APPLICATION NO.	FILING DATE	FIRST NAMED INVENTOR	ATTORNEY DOCKET NO.	CONFIRMATION NO.
10/616,218	07/08/2003	Yechiel Gotfried	03398/LH	9774
1933 7590 06/14/2007 FRISHAUF, HOLTZ, GOODMAN & CHICK, PC 220 Fifth Avenue 16TH Floor NEW YORK, NY 10001-7708			EXAMINER	
			ARAJ, MICHAEL J	
			ART UNIT	PAPER NUMBER
			3733	
		•	MAIL DATE	DÉLIVERY MODE
			06/14/2007	PAPER

Application No.	Applicant(s)				
Office Action Summary		10/616,218	GOTFRIED, YECHIEL				
		Examiner	Art Unit				
		Michael J. Araj	3733				
The MAILING DATE of this communication appears on the cover sheet with the correspondence address Period for Reply							
A SHORTENED STATUTORY PERIOD FOR REPLY IS SET TO EXPIRE 3 MONTH(S) OR THIRTY (30) DAYS, WHICHEVER IS LONGER, FROM THE MAILING DATE OF THIS COMMUNICATION. - Extensions of time may be available under the provisions of 37 CFR 1.136(a). In no event, however, may a reply be timely filed after SIX (6) MONTHS from the mailing date of this communication. - If NO period for reply is specified above, the maximum statutory period will apply and will expire SIX (6) MONTHS from the mailing date of this communication. - Failure to reply within the set or extended period for reply w

Figure 1 ('889)

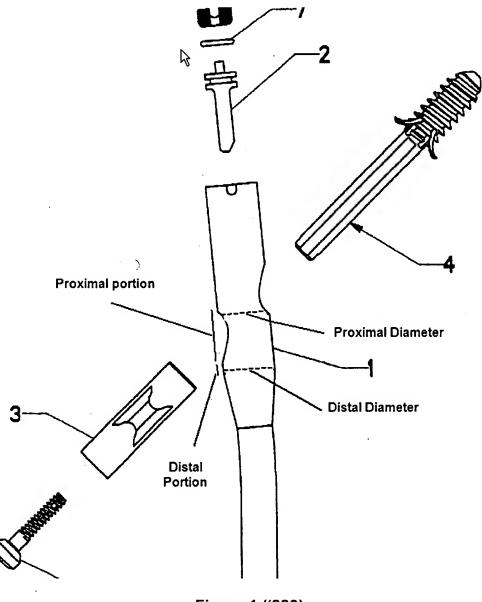
Bramlet et al. disclose an intramedullary nail comprising a proximal head that defines at least one hole therethrough, a sleeve comprising a locking mechanism that is adapted to engage the whole when the sleeve is inserted in the hole and a screw where the sleeve is adapted to slidably receive the screw. The head has a distal portion and a proximal portion where the proximal portion has a diameter less than or equal to about 80% of the distal diameter. (see Figure 1 below) The distal portion defines at least one hole therethrough and comprising a sleeve (3), which comprises a locking mechanism (2). This locking mechanism prevents longitudinal and rotational movement of the sleeve with respect to the nail. Also disclosed is that the intramedullary nail is adapted to be implanted in the bone, such that no portion of the nail extends to an external

surface of the bone. It also can be interpreted that the proximal head has a visually discrete distal portion and proximal portion. (See Figure 25) There is also a visual discreteness between the proximal and distal portions with respect to the angled hole for the sleeve. There is a sudden narrowing between the proximal and distal portions (as seen below).
